PLANNING BOARD MEETING

AGENDA

RANDOLPH ROAD PROJECT QUESTIONS

COVER SHEET
RANDOLPH ROAD, MULTIPLE PARCELS
WAREHOUSE DISTRIBUTION FACILITY
RANDOLPH, MASSACHUSETTS

RANDOLPH ROAD OVERLAY PLAN
RANDOLPH ROAD, MULTIPLE PARCELS
WAREHOUSE DISTRIBUTION FACILITY
RANDOLPH, MASSACHUSETTS

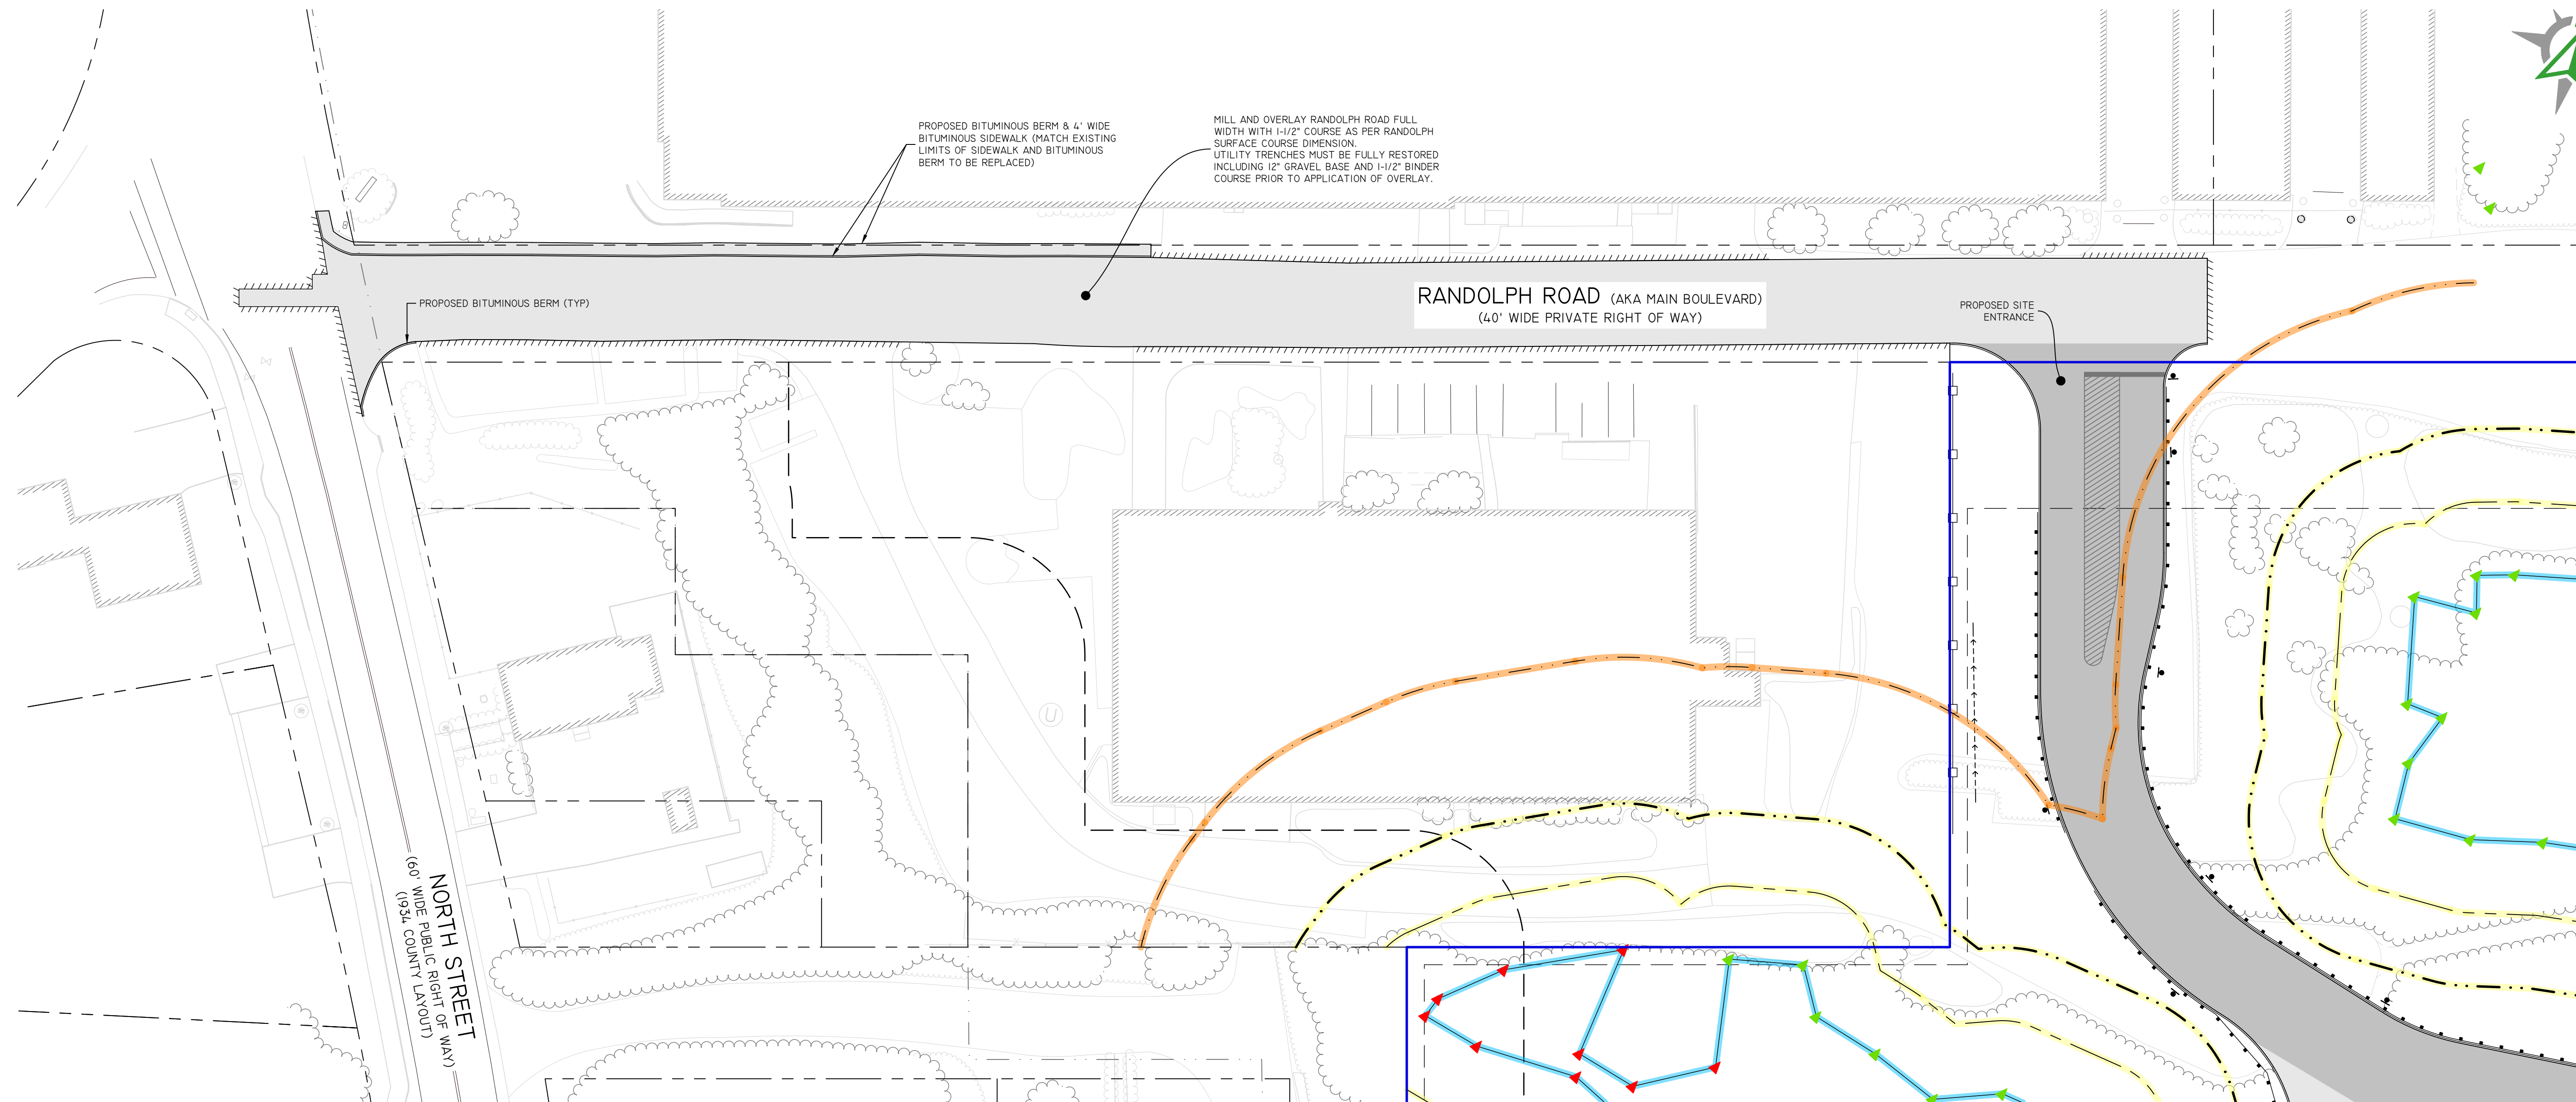
1. The site layout (sheet 7) specifies a 40-foot-wide landscape buffer between the jersey barriers and the property line. In viewing the cross-section sketch that provides the bedrock detail AFTER blasting, it appears that there is a catchment trench at the bottom, width to the sloping bedrock and a layback slope where the overburden material is sloped back. Based on this, it appears that instead of a 40-foot landscape buffer, that it may actually be closer to only 15-20 feet wide.

- a. What is the possibility of reducing the catchment area for falling bedrock to 5 feet especially where there are jersey barriers?
 - b. Concerned that the setback could damage the root system of trees remaining in the buffer space at the top.

Rockwall/Bedrock natural stone face: Mr. Buckley noted that since the project inception, one of the critical components was to mitigate any impact on abutting residential properties. The rock face minimizing grading and preserves the mature vegetation along the perimeter supplemented by additional plantings in any gaps in the existing vegetation.

Considering the 10' removal for overburden at the top of the bedrock and the size of the rockfall zone, Chairman Plizga is concerned there won't be as much of a vegetation buffer between the properties and wondered if the rockfall area could be minimized. Mr. Norton noted it could not be any less than 12-15'. Chairman Plizga asked if there is any way to shorten up the 60' isles for the truck court so the building could be shifted back to maximize the buffer. Mr. Buckley noted that to relocate the building at this point would be a monumental task as all the project calculations have already been prepared. There was a discussion regarding ways that the catchment (rockfall) area and overburden area could be minimized to preserve/increase the vegetative/landscape buffer. Mr. Buckley suggested a condition whereby the applicant would endeavor to minimize the catchment area. Chairman Plizga would like the team to look at ways they could keep the vegetated area to a minimum of 25 feet. Mr. Buckley said they will seek to minimize the catchment area where possible, and where safety outweighs the ability to do so, they would enhance screening in that area. Mrs. Alexopoulos does not want to sacrifice too much on the safety side and would like screening (plantings) added with attention to placement.
